UNITED STATES PATENT AND TRADEMARK OFFICE

APPLICATION NO.	FILING DATE	FIRST NAMED INVENTOR	ATTORNEY DOCKET NO.	CONFIRMATION NO.
10/768,382	01/29/2004	Jeff Bremmon	3156.17US02	3782

Office Action Summary	Application No.		Applicant(s)	
	10/768,382		BREMMON ET AL.	
	Examiner		Art Unit	
	Jon A Szumny		3632

This is the first office action for application number 10/768,382, Universal Mount Bracket, filed on January 29, 2004.

Application number US 2002/0033436 to Peng et al.

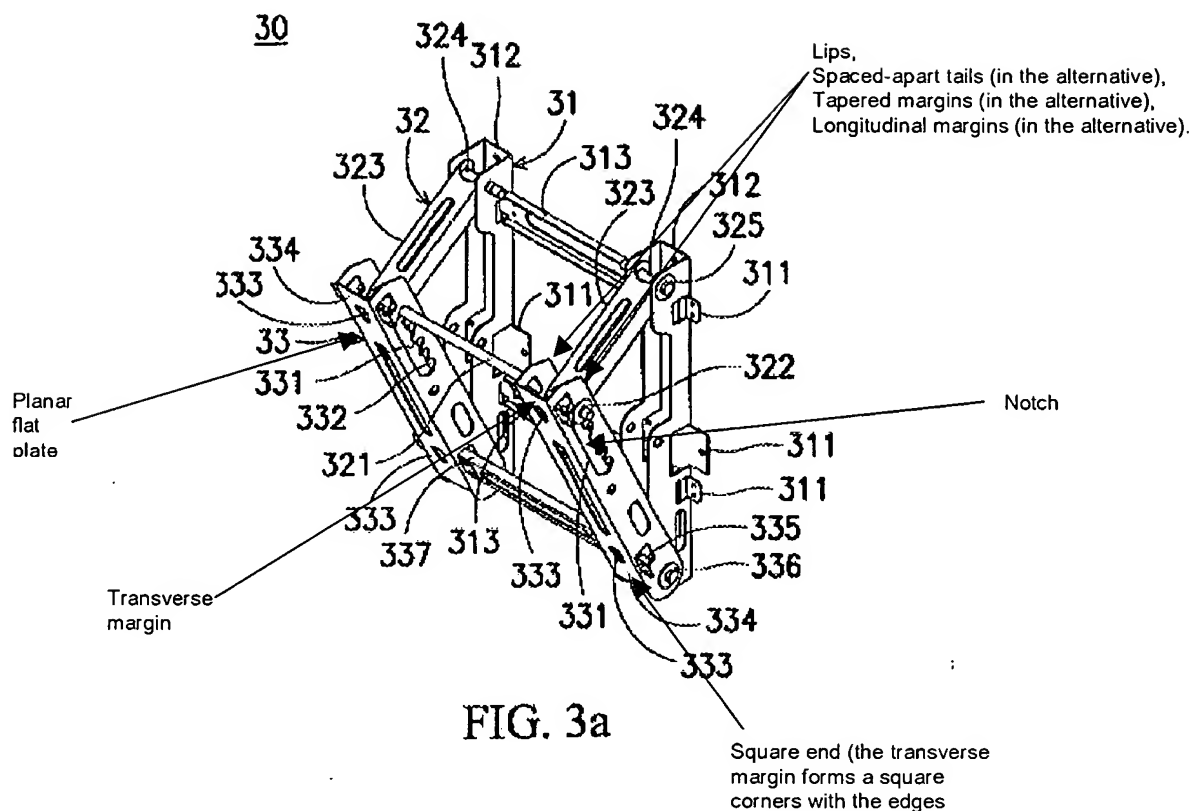
Regarding claims 1-4 and 8-11, Peng et al. '436 divulges a mount (above) for mounting a flat panel display (40) comprising a mount structure (312, left and right sides) shiftably coupled (via 323, left and right sides) to a pair of mount brackets/mount bracket set (334, left and right sides) each having a substantially planar flat plate (above) with a series of mounting bores (333) defined therein, wherein each bracket is a mirror image of the other mount bracket, wherein each bracket has a lip (above) formed along first and second longitudinal side margins.

With respect to claims 5 and 12, Peng et al. '436 alternatively teaches each mount bracket to have a square and opposed ends, the opposed end having a transverse margin and two spaced apart tails (above).

With respect to claims 6 and 13, Peng et al. '436 alternatively teaches each mount bracket to have a square and opposed ends, the opposed end having a transverse margin and a tapered margin adjacent the transverse margin (above).

With respect to claims 7 and 14, Peng et al. '436 alternatively teaches each mount bracket to have a notch (above) defined in a longitudinal margin.
